REGIONAL DISTRICT OF NANAIMO

REQUEST FOR TENDER No. 23-016

Lee and Hall Road Pump Stations – Platform Upgrades

Addendum 2
Issued: March 3, 2023

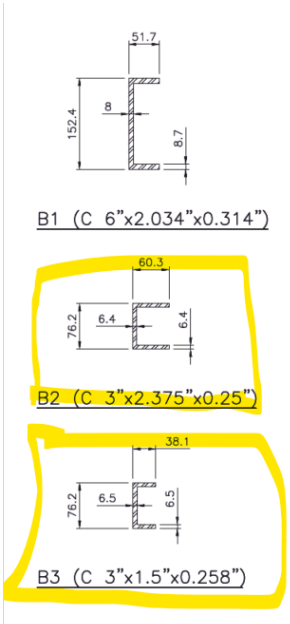
Q1) Is it possible to utilize two of B-3 configurations back-to-back versus the B-2 configuration? Or a combination of channel and L Iron to meet the 60.3 landing surface and the strength?

A1) Regarding the substitution for the SS B-2 members, it would be acceptable to substitute two (2) of the SS B-3 members arranged back to back provided that they are welded together at the top and bottom with stitch weld and noting that some slight adjustments will be required to the locations of the mounting plates to which they are attached. Alternately, a bent or fabricated SS B-2 member could be utilized.
